Subject: RE: Draft Environmental Impact Report for the proposed modification to the existing CEMEX Rockfield Quarry (EIR No. 7763 and Unclassified Conditional Use Permit Application Nos. 3666 and 3667)

# Comments on the Draft Environmental Impact Report: CEMEX Rockfield Quarry: Rockfield Modification Project (EIR 7763) and Unclassified Conditional Use Permit Applications No.s 3666 and 3667

Figure 1. From the San Joaquin River Parkway Master Plan. Siting of existing and proposed multiuse trails with two crossing of the San Joaquin River.

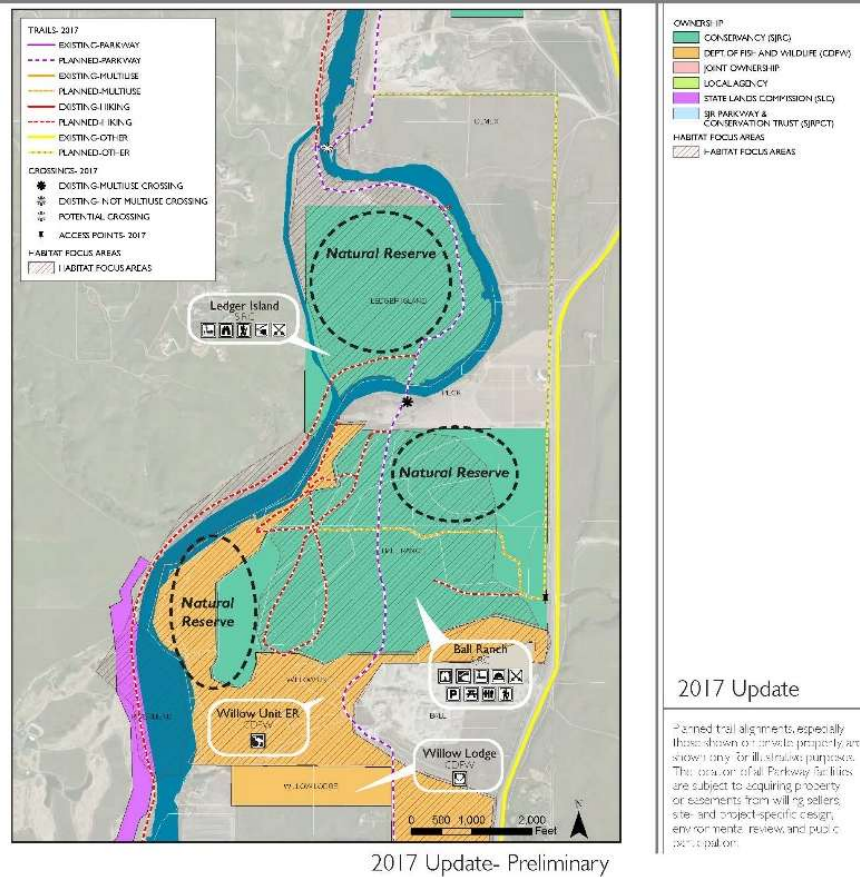
For Transportation impacts, especially for those that involve the safety of pedestrians and bicyclists, there are several mitigation measures that could reduce the over impacts of this proposed projects. The City and County of Fresno have identified multiple intersections along Friant Avenue within the likely travel routes for the gravel trucks. The County should consider the installation of pedestrian and bike bridges at the intersections of Fresno, Audubon, Shepard, Fort Washington, Champlain, Copper, and Willow. Potentially these overcrossings can be completed over time, with those nearest Woodward Park being the highest priority. Related to this is the impacts to the San Joaquin River Parkway multiuse trail. Although CEMEX states in their supporting documents that they could work with the San Joaquin River Conservancy to build this between the plant and Friant road, and along their quarry pit, both of these alignments will still have safety concerns with the increased truck traffic. The County should require that CEMEX build a the multiuse train and underpass at the entrance to their plant, in addition to constructing the multiuse trail on Ball Ranch, connecting by a bridge across the river to Ledger Island, and then reconnecting to the Fresno side of the river upstream of the quarry site and connecting it to Lost Lake Park. These additions would keep pedestrians and bicyclists away from the quarry and allow for safe travel by the plant site. In addition, this should also take more bicycle traffic off of Friant Road and avoid safety considerations of increased traffic.

Figure 2. Figure 2-1 form DEIR showing the Plant Site's existing conditions. Note the property boundaries versus the project area disturbances and the location of the silt pond.

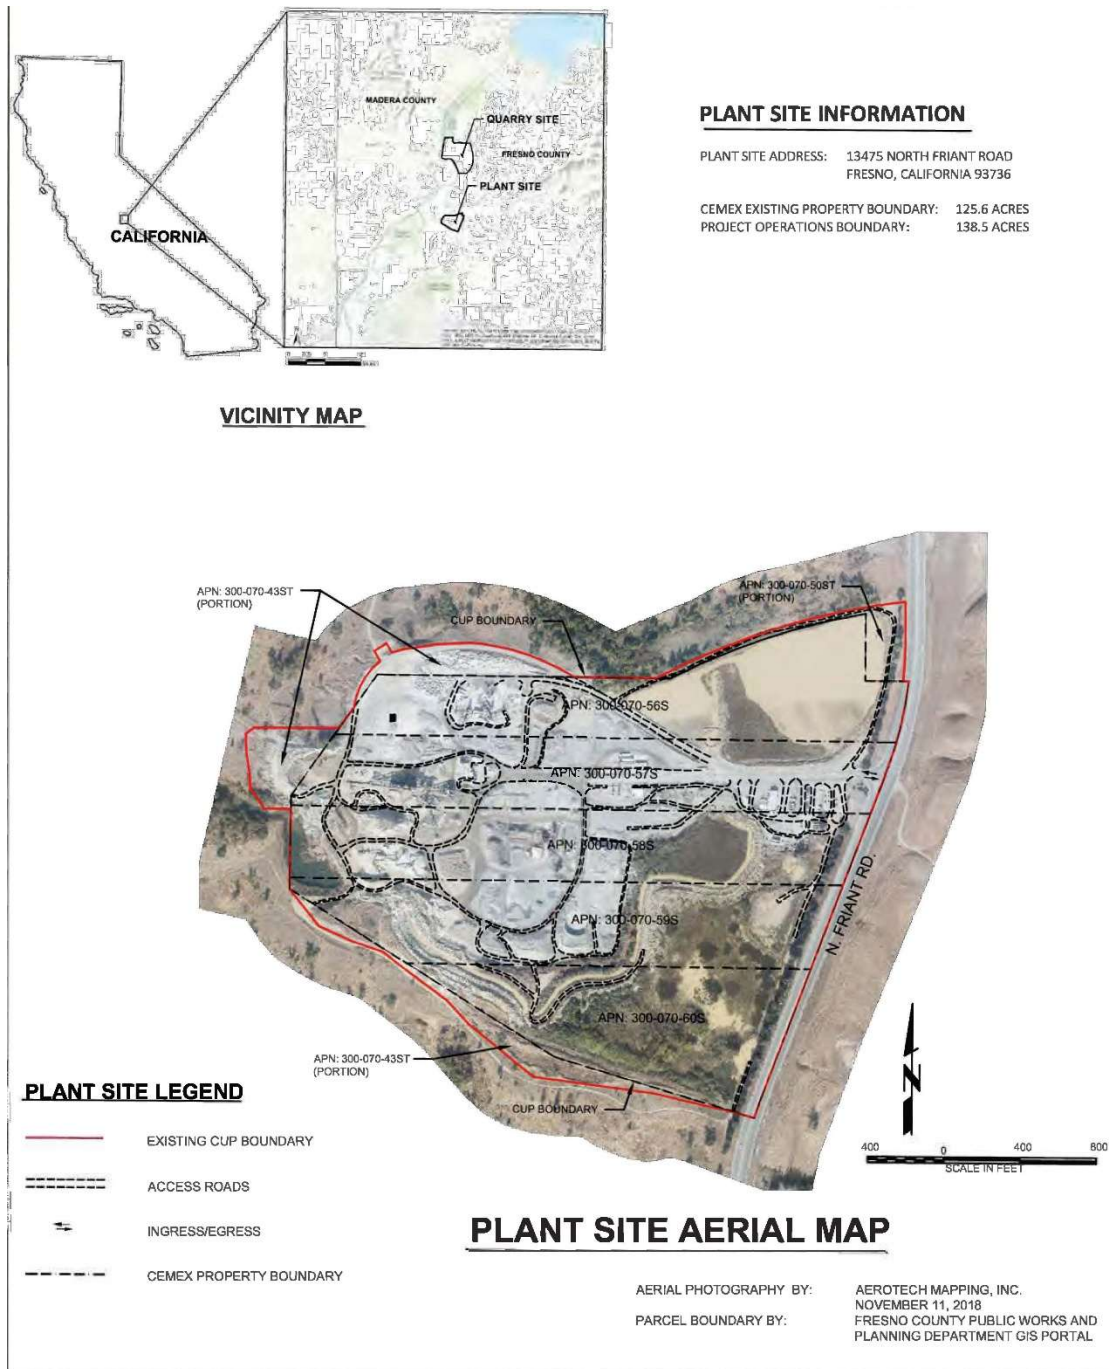
The proposed project at the plant site (Figure 2) does not discuss past levee breakage and loss of water from the silt pond. Although the proposed project describes some protection from discharges of the silt pond, there is not much information on any increase in design characteristics to the levee than can justify more confidence that further discharges will not happen. As seen in Figures 3-7, the silt pond is located next to the active flood plain of Little Dry Creek and has likely discharged silt and silty water into that flood plain. With the existing water quality constituents of the silt pond as reported in DEIR, the proposed project should provide strong mitigation measures to assure that the levee separating the silt pond from Little Dry Creek is much stronger, better monitored, and include a spill cleanup and abatement plan.

Figure 2 also shows the CUP boundary, which is also described as the Project Area for the plant site. A very important area that is not included, but should be, is the inlet ditch that supplies water to the plant. Figure 3 also shows, approximately, the location of the inlet ditch as it connects to the plant site on its western boundary, travels west before turning north and connecting to the San Joaquin River. A very important note is that the ditch crosses Little Dry Creek at grade, causing the waters to commingle (Figure 9). The ditch supplies project related water supplies, and has required maintenance in the past, which is likely to continue being required for flow. For this reason, it should be included in the project area and its continued operations and maintenance described and mitigation for continued negative impacts covered.

Figure 9: Rockfield water supply ditch with a focus on the crossing of Little Dry Creek from Google Earth, access in March 2025 and using the time series tool to show October 2023. Note the water within Little Dry Creek downstream of the inlet ditch crossing.

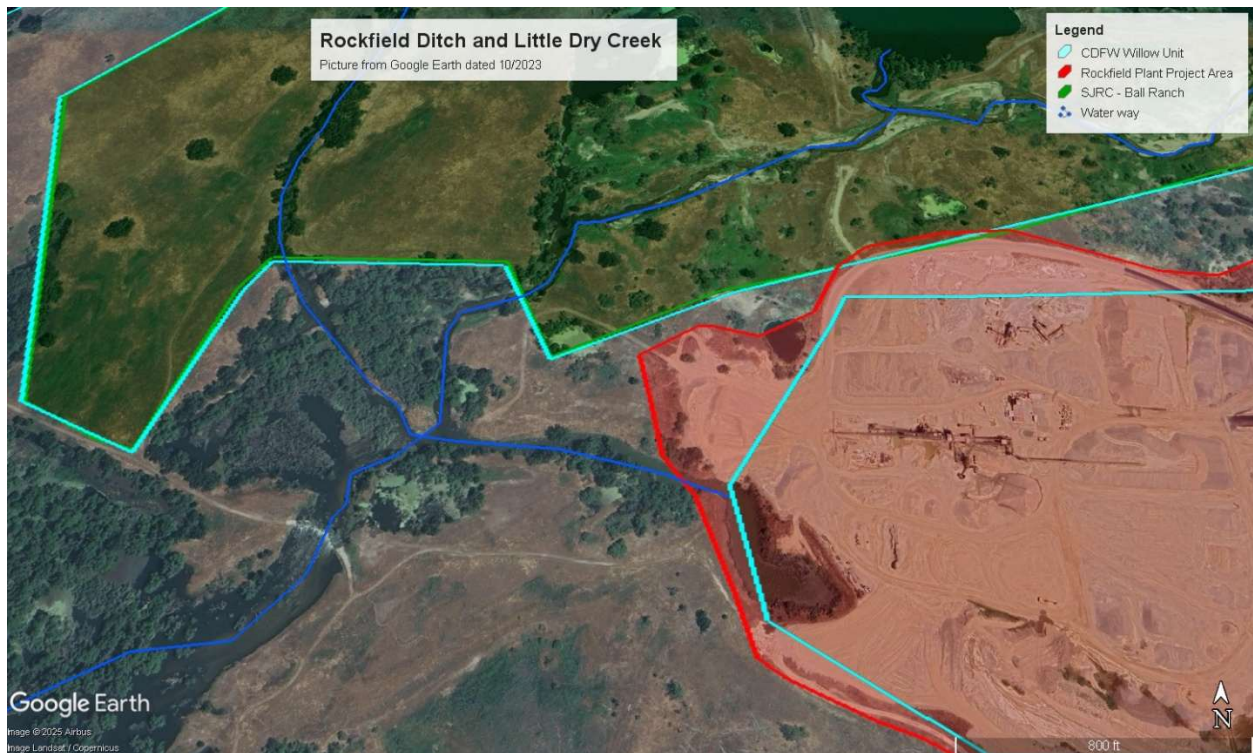
For example, Figure 10 shows how close land disturbance is to the inlet ditch pond at the plant site. This proximity of disturbance can allow silt and other contaminants to enter the water in the inlet ditch. With flows of Little Dry Creek, the likelihood of flow going back towards the River is likely. As with the water quality of the silt pond, water quality of the inlet ditch needs to be described. Mitigation and monitoring requirements need to be put into place to avoid, if possible, on going and future negative impacts. Siltation of fine sediments is especially problematic for the fisheries of the San Joaquin River and is identified as potential issues in the continue efforts as reestablishing a run of Chinook salmon.

An important mitigation measure to avoid some of the most important negative impacts from continued operations at the plant site is to separate the ditch water from Little Dry Creek. A siphon or some other such infrastructure should be required. In addition, none of the background information describes a right to use water from Little Dry Creek, and with the water comingled, CEMEX is taken water from a water body without any clam of rights for that.
